Service Letter

Subject: Bell 407 Air Conditioner Blower Motor Connector Upgrade.

Applicability: Bell Helicopter model 407 Equipped with the Air Comm Corporation 407EC-201, -202, or -203 air conditioner systems

Reference: ACC Service Bulletin SB 407-110414

Figure 1 Blower Assembly S-6102EC-4 used in the 407EC-202-1,-2,-3 and 407EC-203-2 AC kits

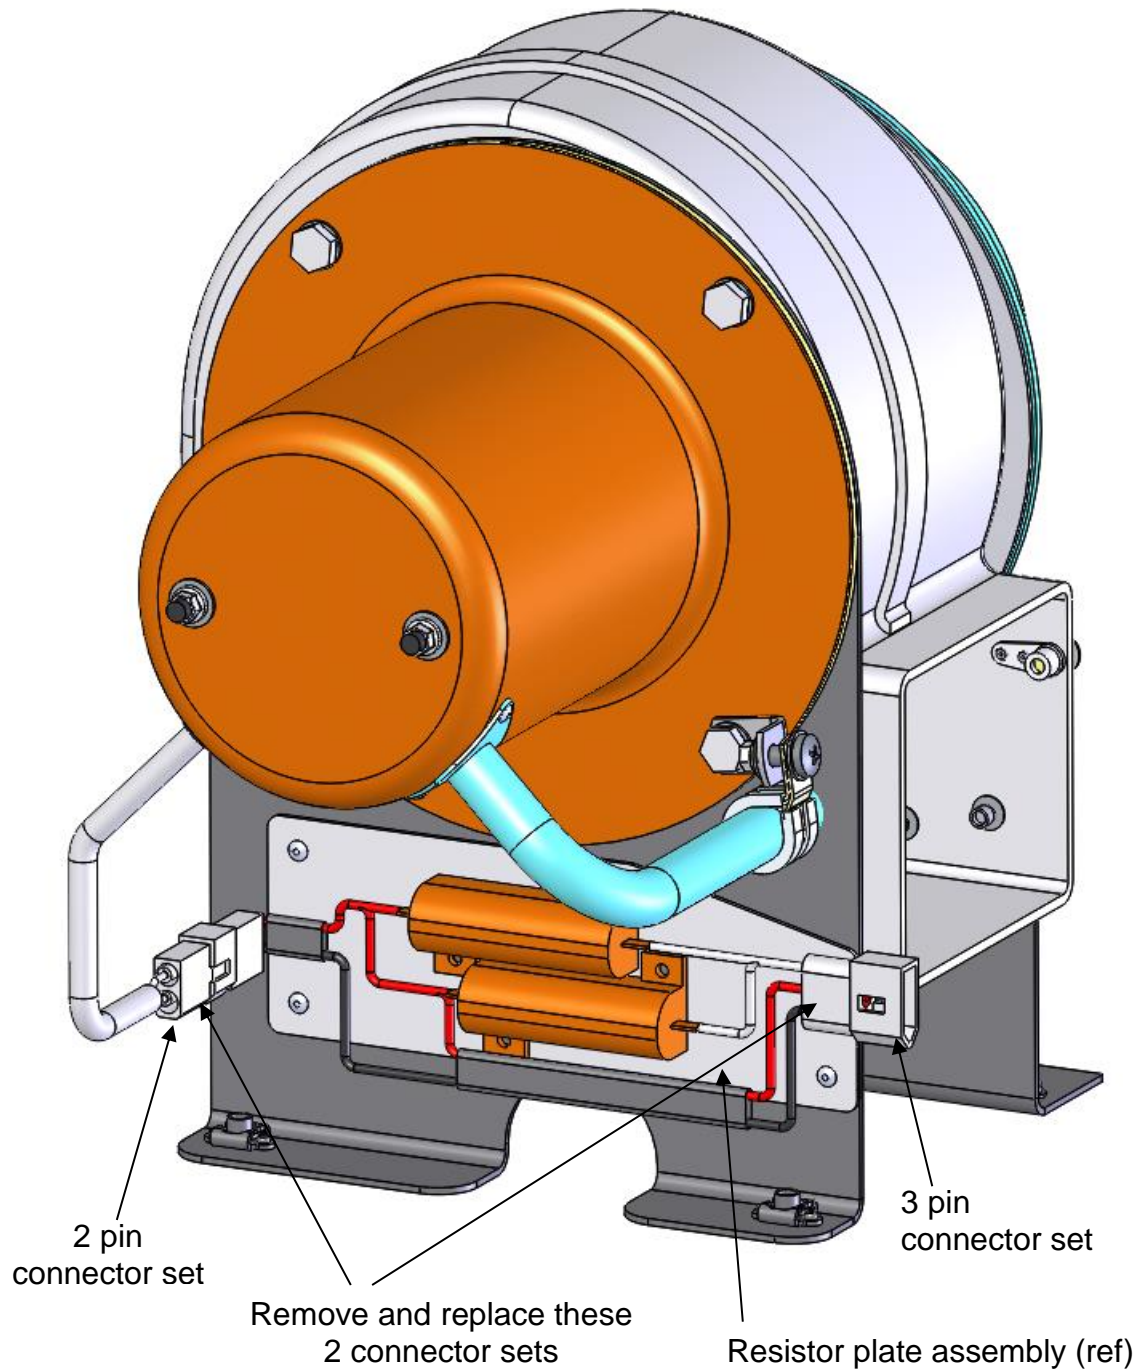
1. Access the aft evaporator assembly, located on the left side above the aft baggage compartment.
2. Locate the 3 pin connector near the resistors on the evaporator (see Figure 1) and mark the white wires "Red" and "Black" as appropriate per figure 2. It may be necessary to remove a portion of the heat shrink covering on the harness.
3. For the 407EC-202 and 407EC-203 kits (with the blower shown in figure 1) cut the wires on the back side of the 4 connectors (2 connector sets) shown in Figure 1. Remove minimal wire length. Remove and discard the connectors w/pins & sockets. For the 407EC-620-2 kits (with the high output blower shown in Figures 3 & 4) remove and discard the 3 pin connector set.

Install pins, sockets, plugs, and receptacles onto free ends of wires.

Crimp Molex pins using Molex Corporation Tool #0638111000 (Available thru Molex USA 1-800-786-6539) or equivalent wire terminal crimping tool for Molex 1189, 1190 series terminals (2.36mm / .093" dia).

Figure 5. S-7062EC -1, -2 Blower Assembly
Used on 407EC-702, -704 Condenser Assembly

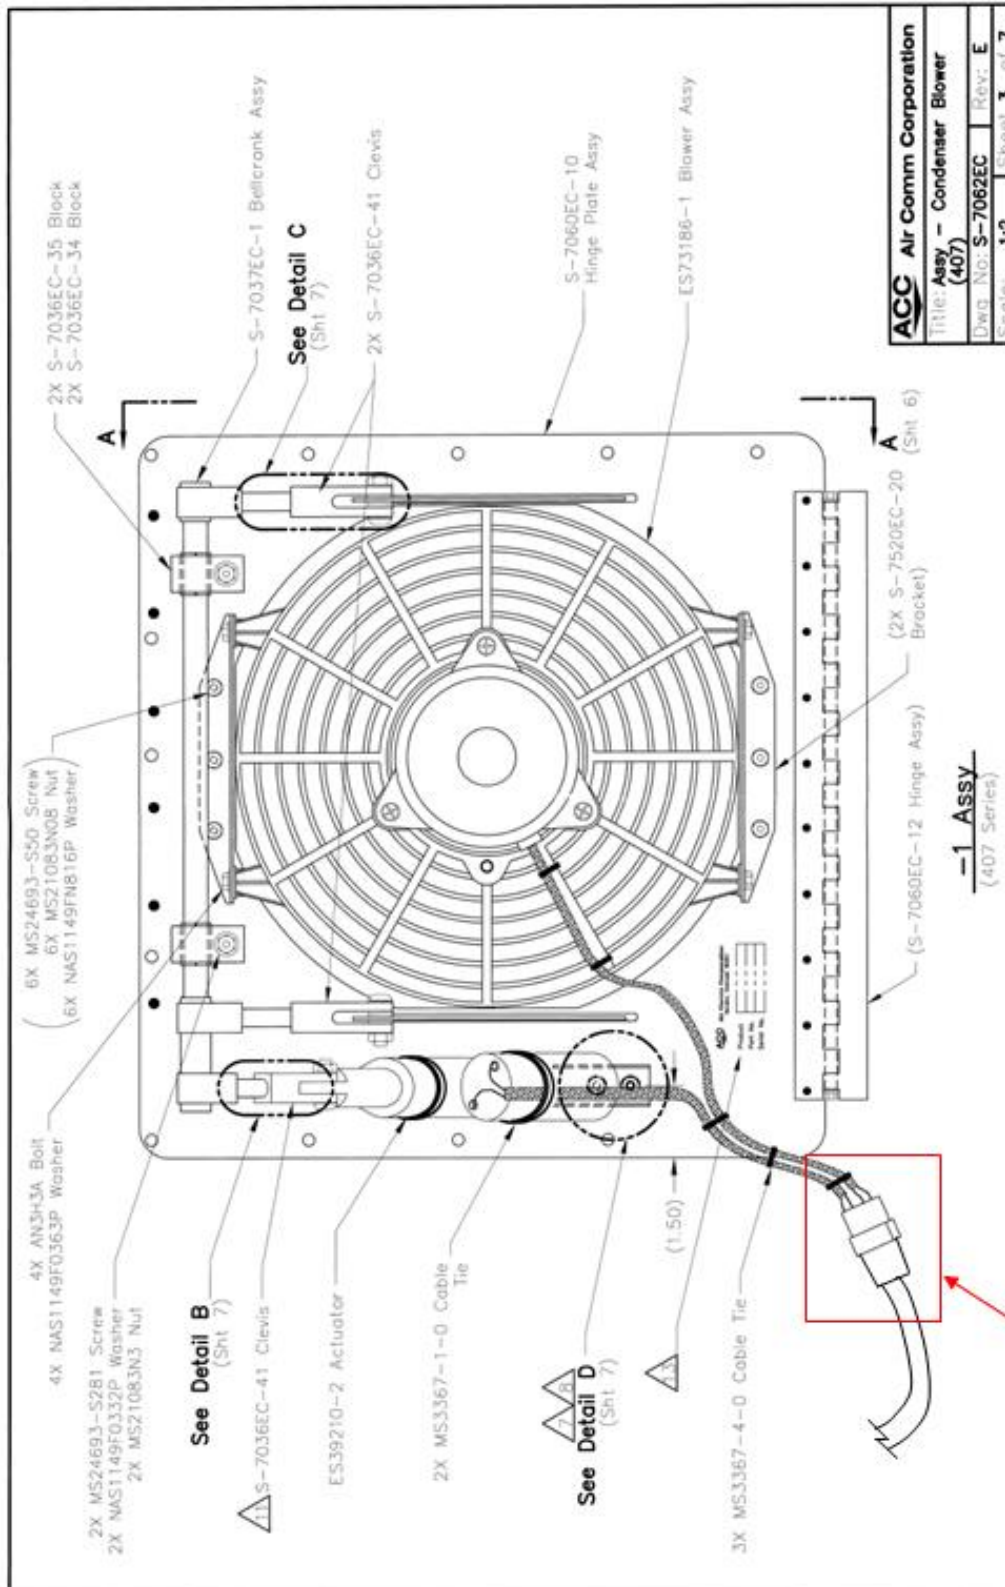
1. Access the condenser assembly, located below the aft cargo compartment. See Figure 5.
2. Locate the 4 pin connector on the blower harness.
3. Identify the wires and remove both the plug and receptacle.

Remove & replace per instructions

Install the supplied pins, sockets, plugs, and receptacles onto free ends of wires.

Because of the 12 ga. wires used on this blower connector the terminals are to be crimped and soldered.
